# United States Department of the Interior

## BUREAU OF LAND MANAGEMENT

Re: R2P2 Minor Modification Request, Skyline Mine, Longwall Panel 6 Left "B", Federal Coal Lease U-044076, Lower O'Connor "A" Seam,

Figure #1  
 General Location, 6 Left "B"

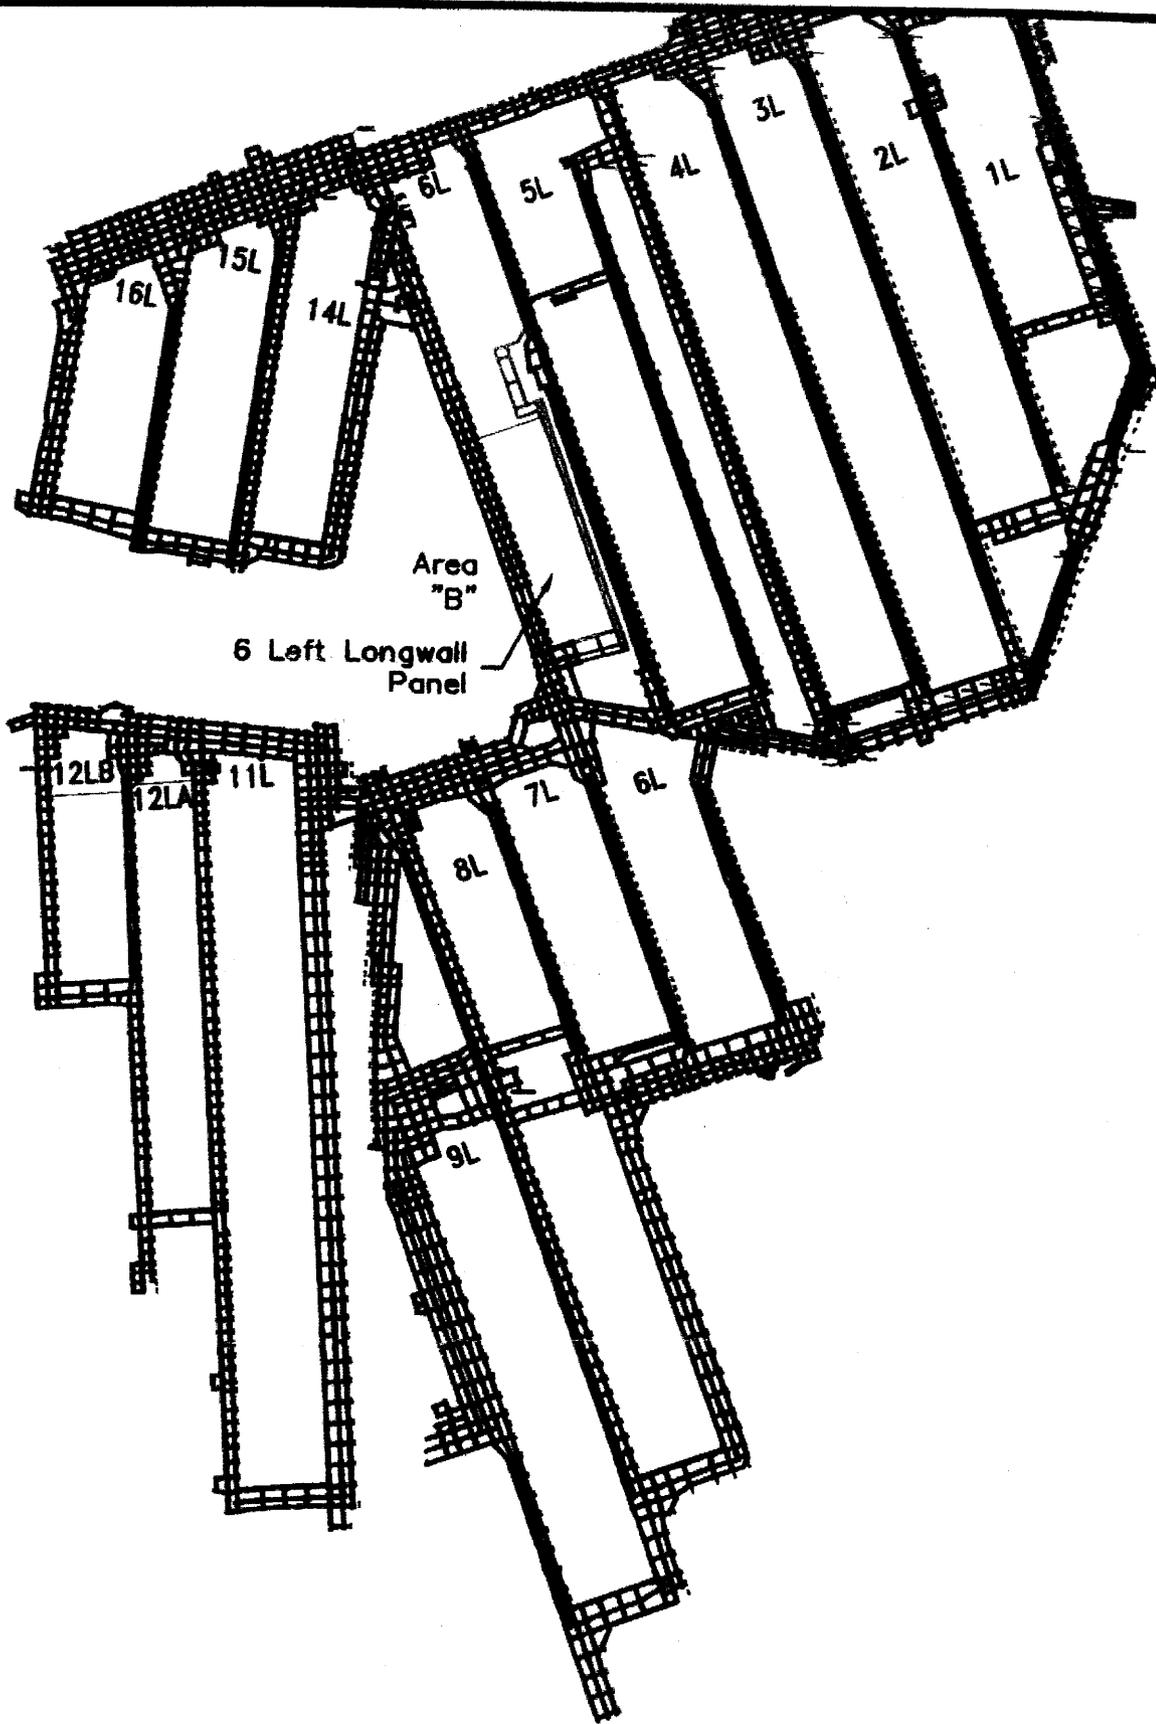
On April 15, 2003, the Bureau of Land Management (BLM) received the written request from Canyon Fuel Company (CFC) concerning the request to modify the approved mining plan (R2P2) for the Skyline Mine. The modification request involves the development of a new tailgate/bleeder (Figure 1), sequencing of the 6 left "B" panel upon completion of the 12 Left "B" panel and the abandonment of the of the longwall equipment upon completion of the panel. They are also requesting the Deletion of Area "B" from the recoverable reserve base.

Approval: BLM approves the development of the new tailgate/bleeders for the 6 Left "B" Panel, extraction of the 6 Left "B" panel upon completion of the 12 Left "B" panel and the elimination of Area "B" from the recoverable reserve base (Figure 2).
